Architect's DSAP Response

MIXED USE DEVELOPMENT

28 FISHER RD / 9 FRANCIS ST, DEE WHY, NSW

MARCH, 2023

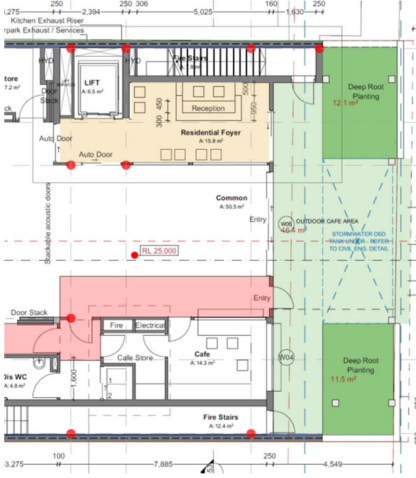
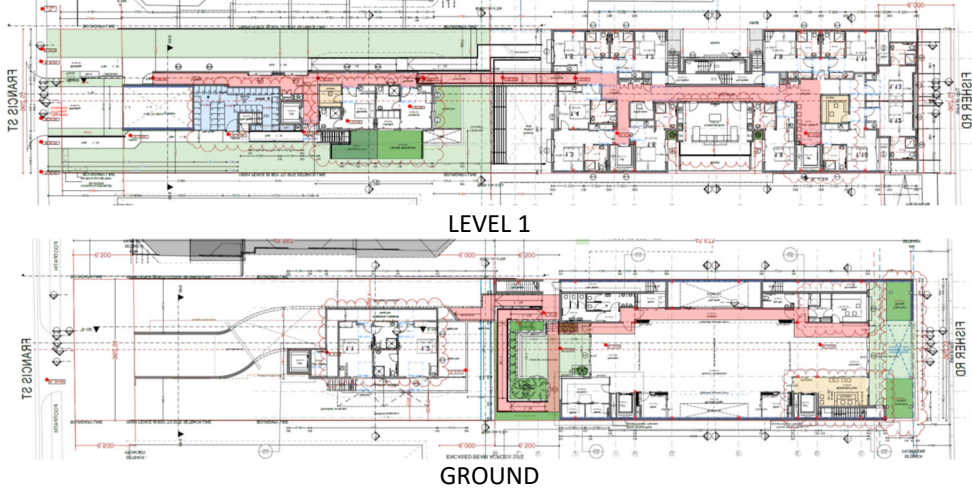
No columns are shown on the plans which make it difficult to assess whether manoeuvrability is possible and convenient through the basement levels and access driveway approach which splits to the 2 levels. 3-point turns are shown at the end of the basement driveways but it's unlikely that disabled drivers would be able to negotiate this. Additionally, it would appear that there is no side setback for spaces 16, 17,18 and part of space 1.

Tandem parking for church goers is awkward; tandem parking is usually provided for co-habitants in the same unit in residential developments.

Priority is provided to the needs of the residents within the basement carparking arrangements.

- Columns and structural zones have now been shown on the plan and initial consultation with Structural Engineers has been undertaken. Layouts of levels respond via replication.
- Ramp turning has been widened and lengthened for greater manoeuvrability and Traffic report supports this.
- Carparking Space widths have been increased to Australian Standard requirements where necessary
- Tandem parking has been minimised to the lower level basement only and this area is designated for church staff use only (who park there daily and for longer periods) and this allows for other church persons to park and come and go as necessary for shorter term. All church persons will be aware of this in a smaller grouping of people that know each other well. Access to the church parking area will be controlled.

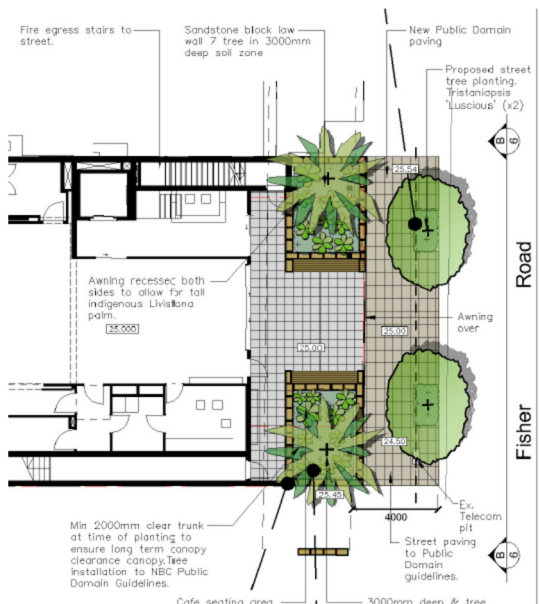
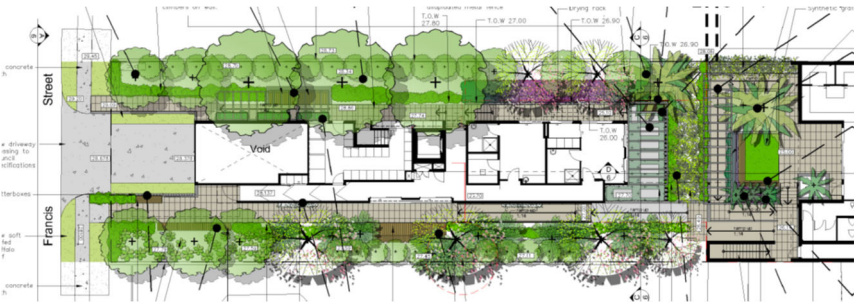
The Panel supports the single car driveway from Francis Street that minimises the impact on the streetscape. The widening of this driveway to provide space for vehicles to wait before entering the basement car park has an undesirable impact on the street and consideration should be given to providing permeable paving to complement soft landscape on the site.

The Panel found the design very difficult to understand. What purpose does the 1:14 ramp for the "Common Outdoor Zone" perform? How is the hydrotherapy pool accessed? Why is it next to the managers private open space?

The alternative access to the Church from Francis Street is awkward and undesirable and this space is best and most appropriately dedicated for residents only.

- Single car driveway vehicle ramp down noted as supported. Permeable landscape at sides of driveway waiting area at the frontage has been incorporated onto the landscaping plan to diminish the required 2-car waiting space at the head of the ramp off Francis St.

- The design has been simplified in relation to access through the outdoor spaces and the Common Zone has been raised to Level 1 (from basement ground level).

- The Hydrotherapy pool has been relocated out of the basement level to Fisher Rd roof as it is likely to be used by participants of Fisher Rd. as a part of rehabilitation when required.

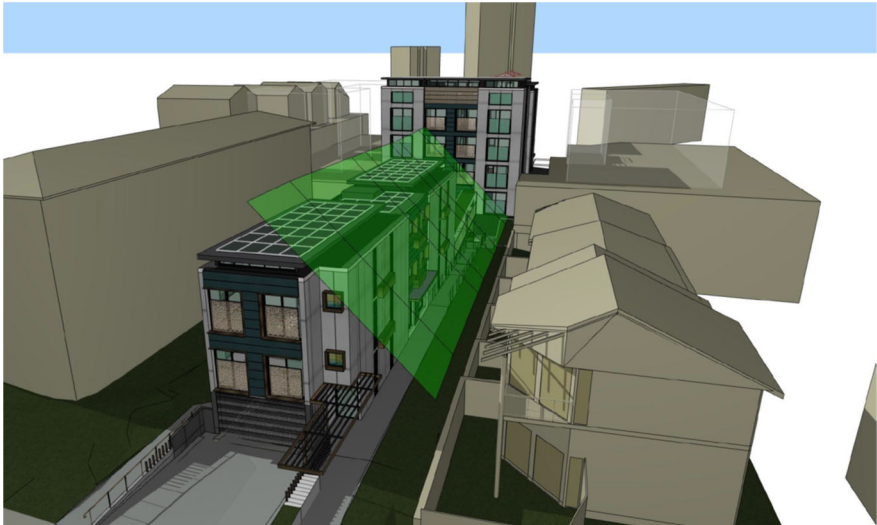
<p>Sustainability</p> <p>Recommendations</p> <p>23. On site battery storage has benefits for the grid and may be a highly desirable back-up during the transition to a de-carbonised grid</p> <p>24. Install EV charging allows for bi-directional (2-way) charging of EV battery for powering the building</p>	<p>Sustainability - Recommendation Response</p> <p>23. There is created room to allow for the installation of on-site battery backup systems. Details and viability of this will be examined as a part of the procurement process.</p> <p>24. EV Charging panels have supplied as significant PV arrays on the roof and these can couple with battery systems.</p>  <p>LONGITUDINAL VIEW OF THE SITE INDICATES PV ARRAYS ON THE ROOF</p>
